HPAC Committee Agenda

July 2, 2025

142 E Main - PA-T1-2025-00271

Ashland Historic Commission
Design Review Form

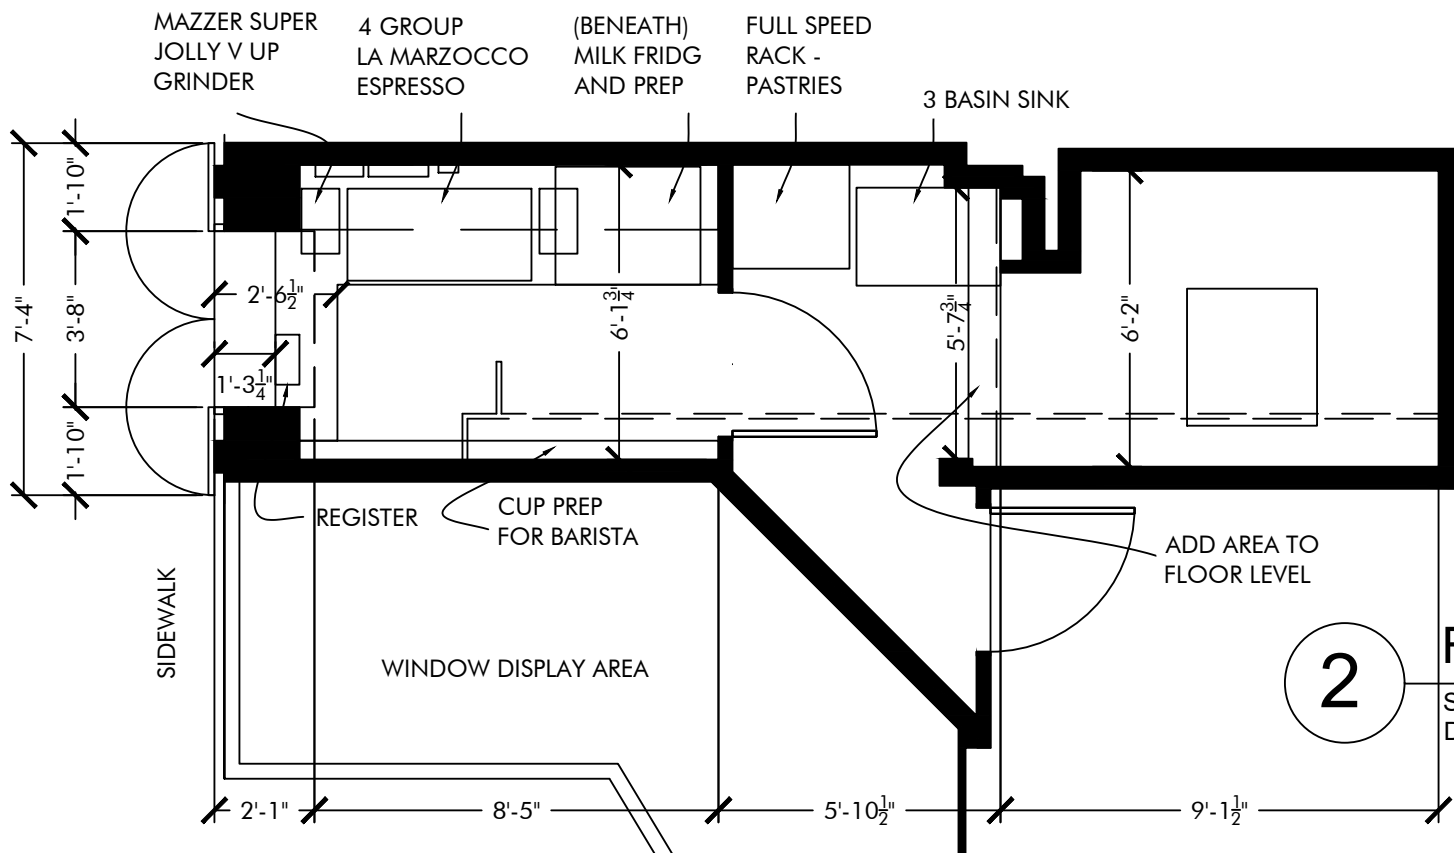
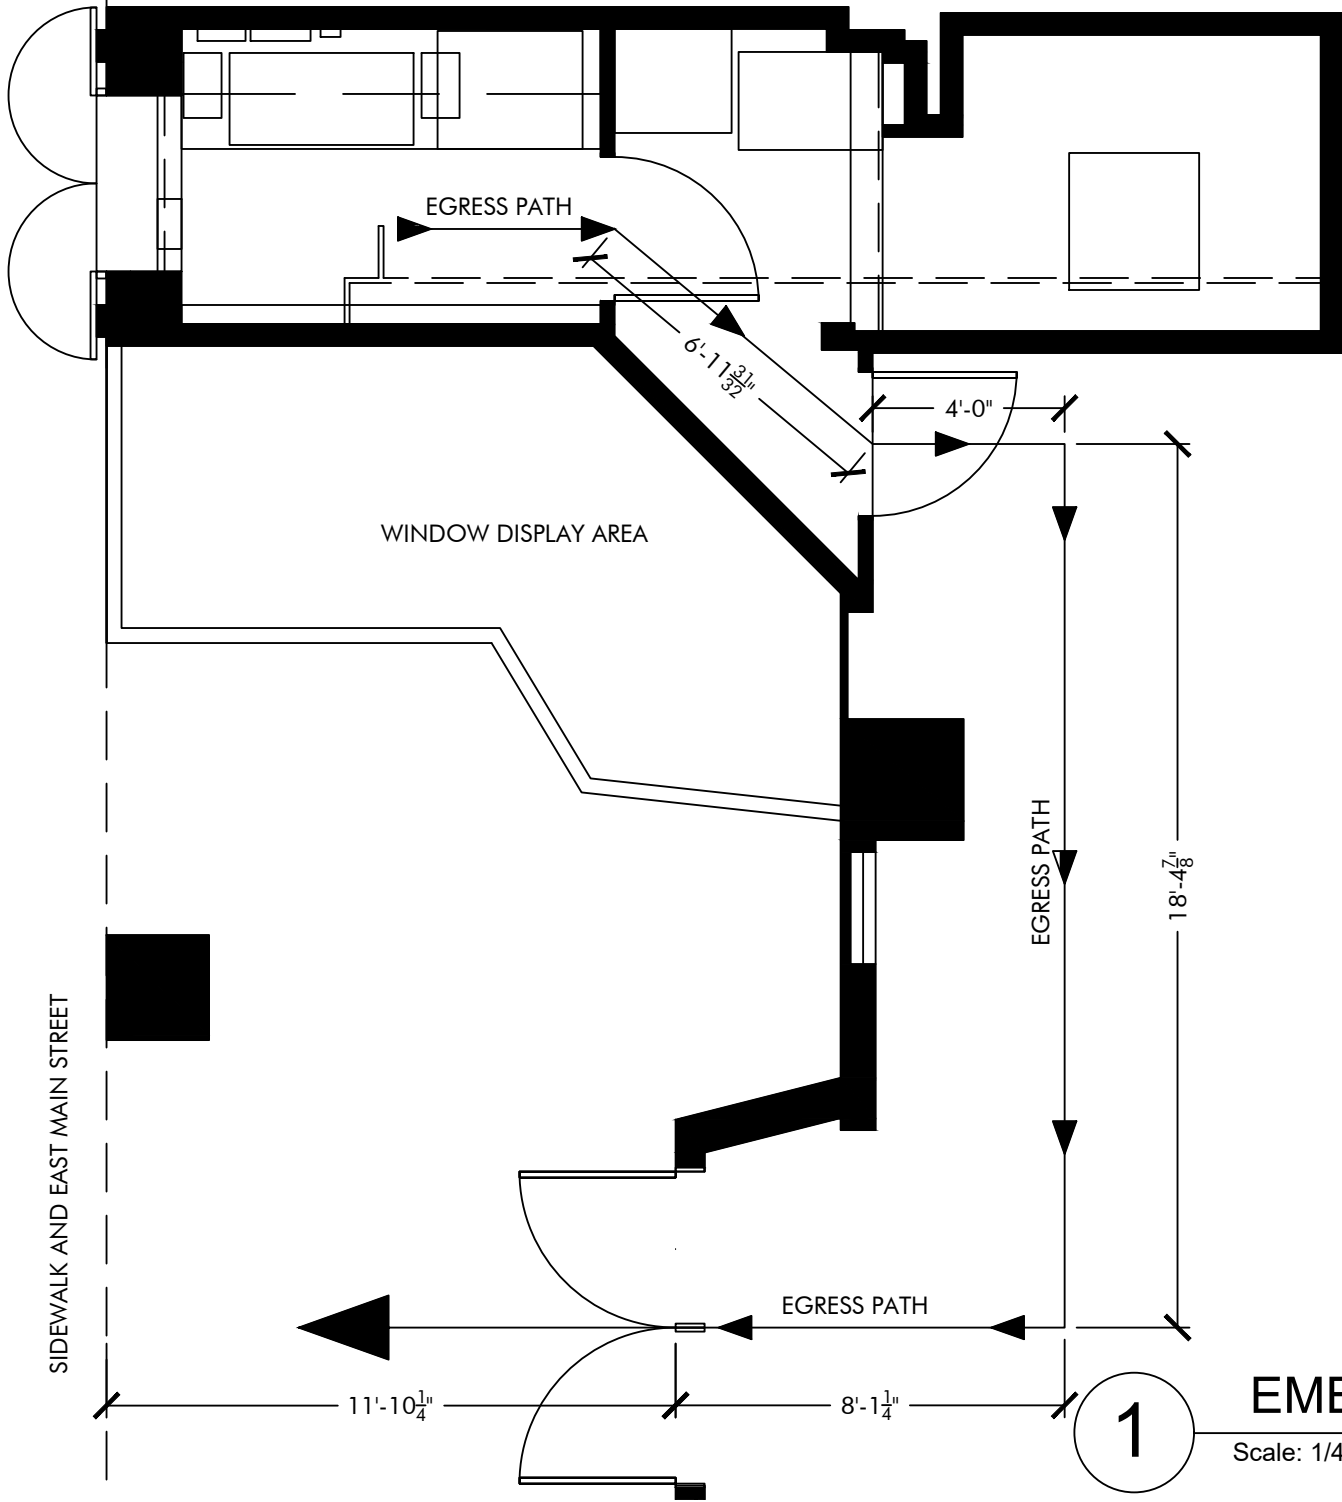
- Supportive of metal awning generally as depicted. (downlighting) & powder coated
- Like that windows match arch above.
- Counter detail to be worked out in final app based on building code requirements.
- No issue with colors, tasteful & well done.
- Great proposal.
